### **MILWAUKIE DESIGN AND LANDMARKS COMMITTEE Monday, March 3, 2014, 6:30 PM**

**Subject:** Kellogg Bridge Pedestrian Lighting

Review and comment on the lighting for the proposed pedestrian bridge under Portland Milwaukie Light Rail Line bridge over Kellogg Lake.

Kellogg Pedestrian Bridge  
Lighting Proposal – Design Narrative  
2/5/14

SCALE 1"=10'

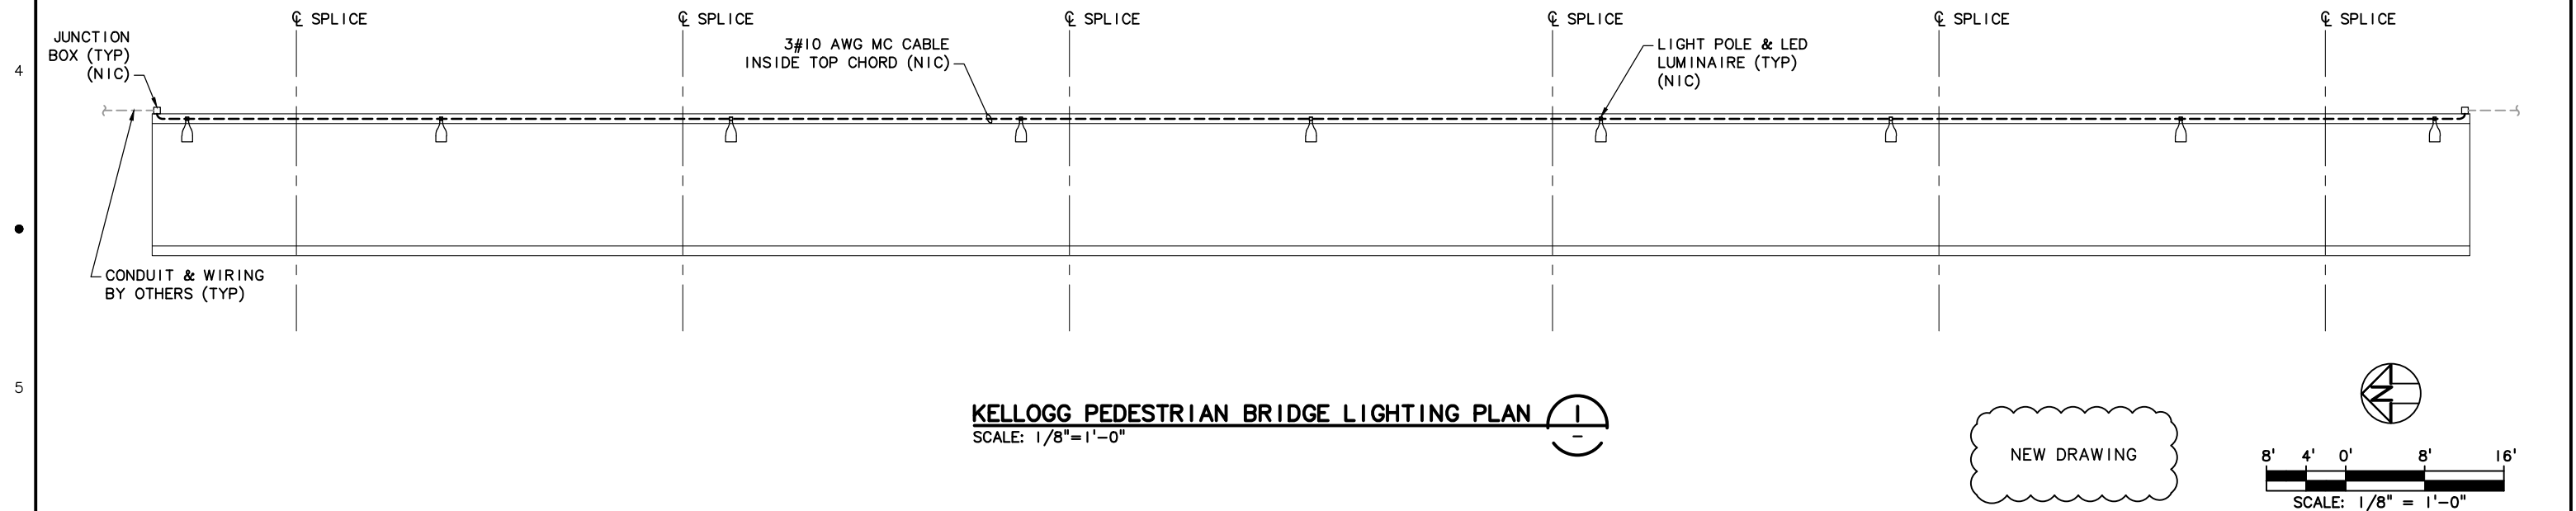
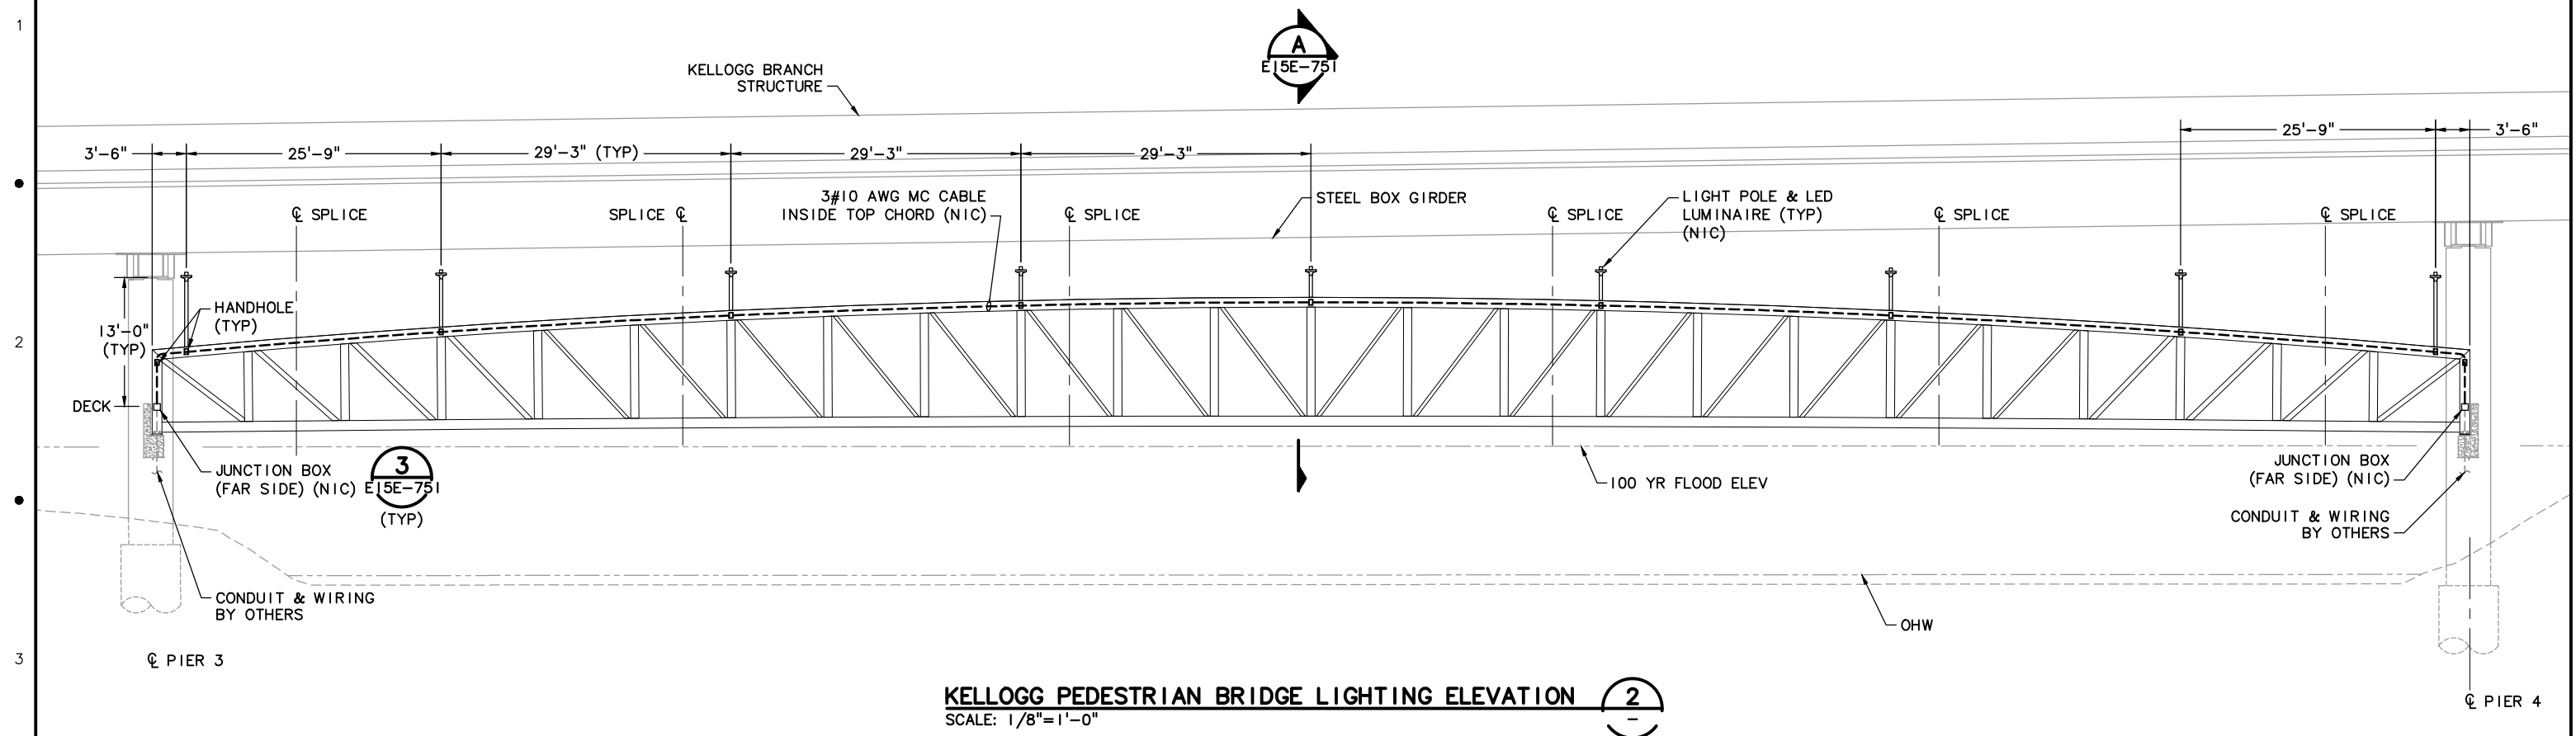
- Is the proposed lighting and the amount of illumination that would be cast beyond the surface of the walkway wildlife-friendly lighting? There is some spillover lighting from the proposed pedestrian lighting. Trimet is checking with the Oregon Department of Fish and Wildlife regarding that agency's standards for light trespass, and should have information available at the meeting on March 3<sup>rd</sup>. The Milwaukie Zoning Ordinance does not have specific lighting guidelines for light spillover. The most relevant standards is MMC 19.402.11.A.9: "Where practicable, lights shall be placed so that they do not shine directly into any WQR and/or HCA location. The type, size, and intensity of lighting shall be selected so that impacts to habitat functions are minimized".

**KELLOGG PEDESTRIAN BRIDGE LIGHTING SECTION A**  
SCALE: 1/2\"/>

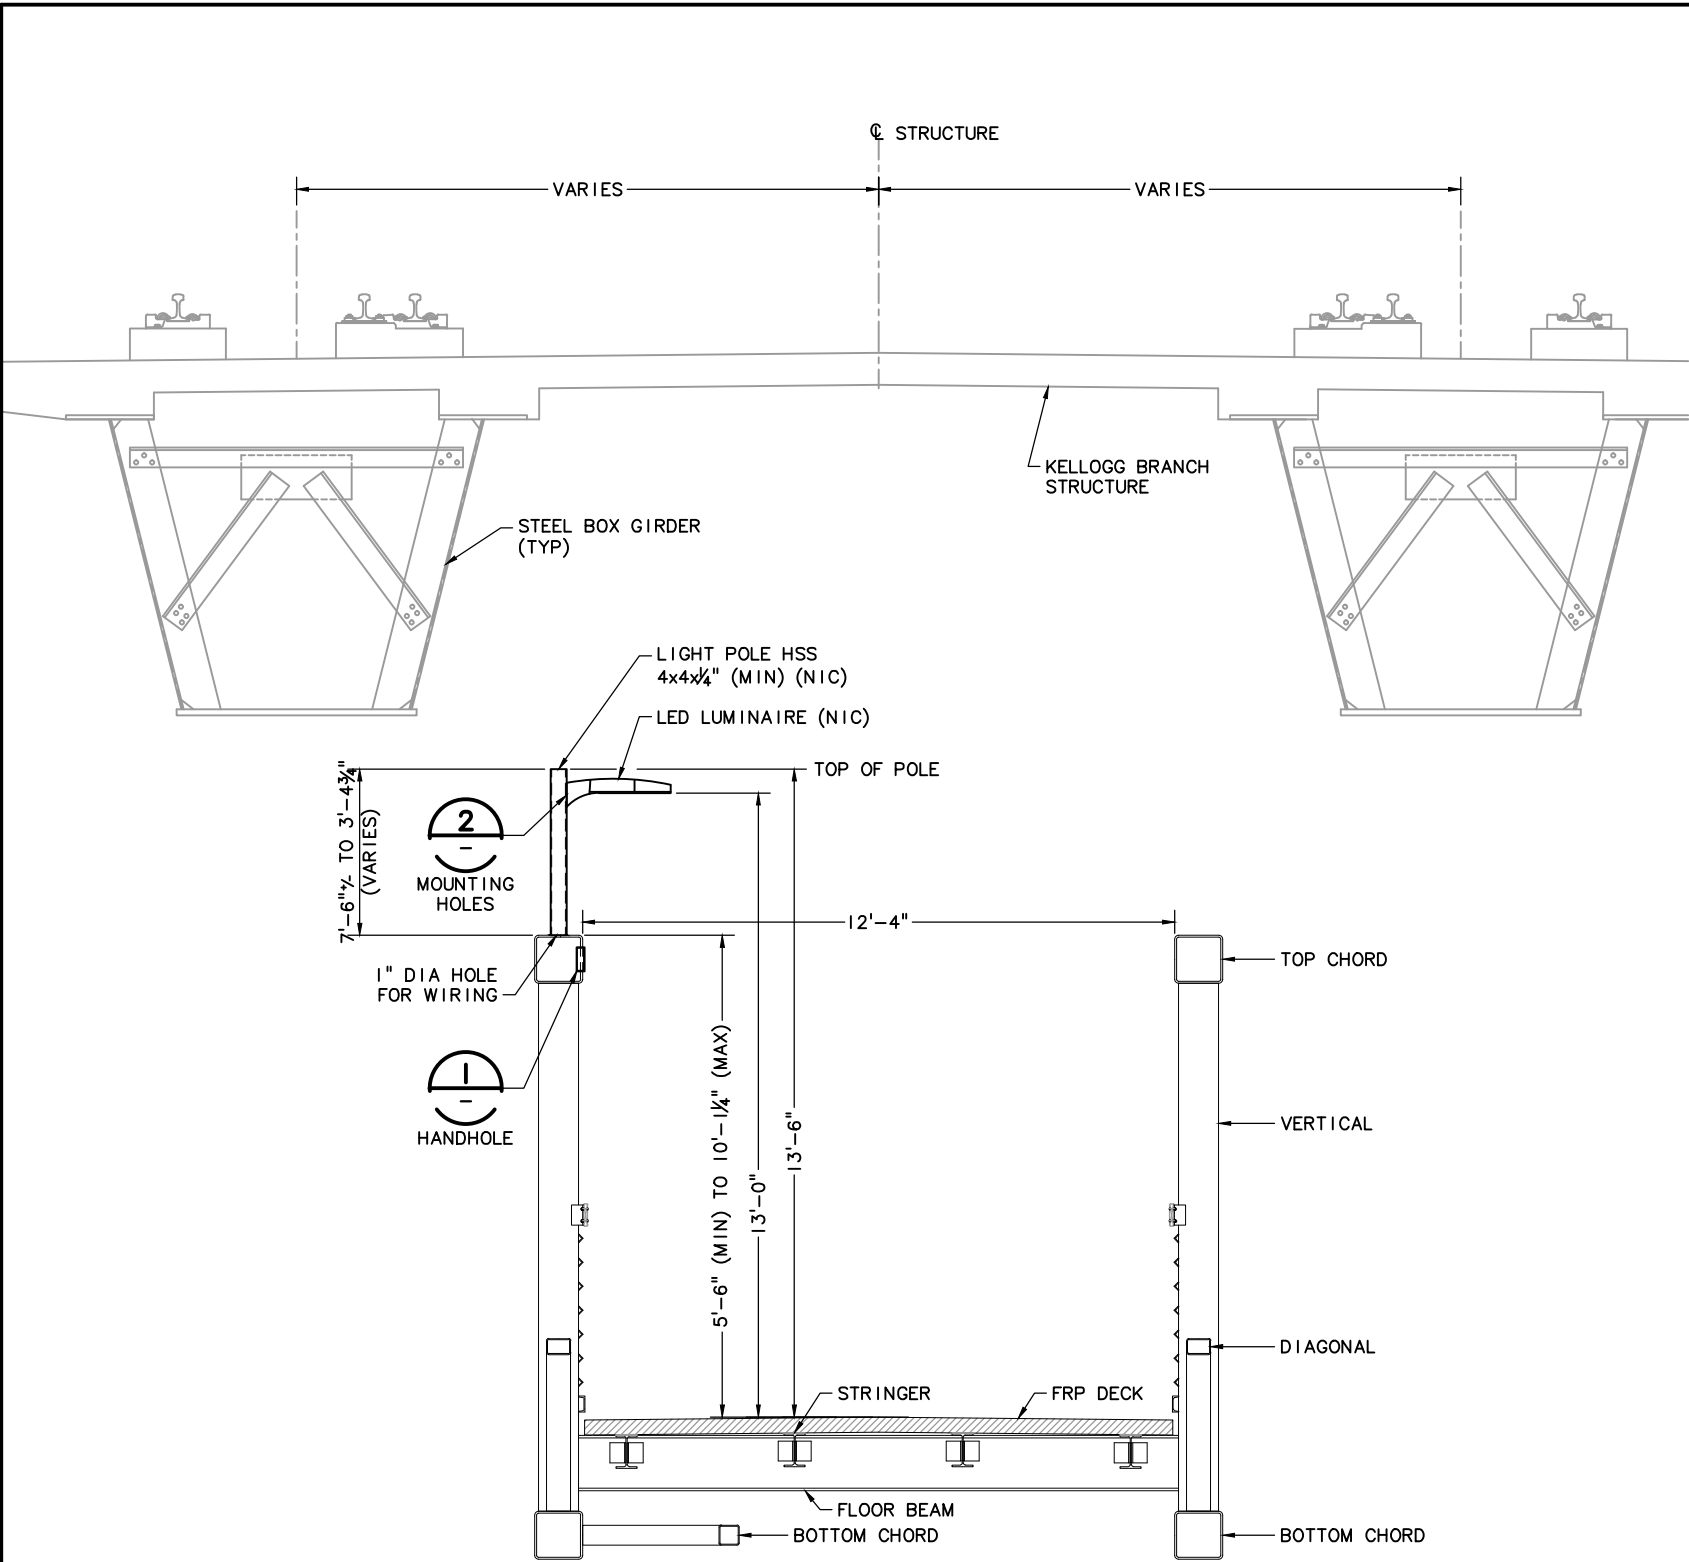
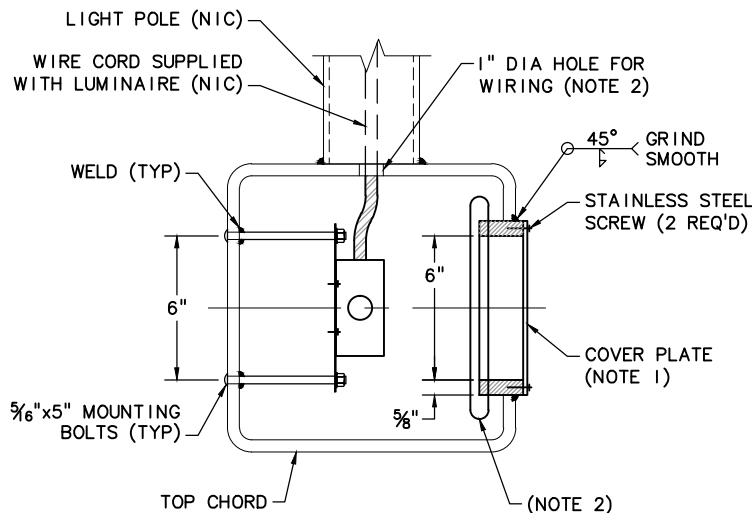
- Does the proposed lighting shield lights from shining directly into windows on residential properties? The applicant has indicated in Attachment 1 that there is a shield on the light fixtures that would prevent glare to residences to the east, which is consistent with the lighting levels shown on the illumination study.
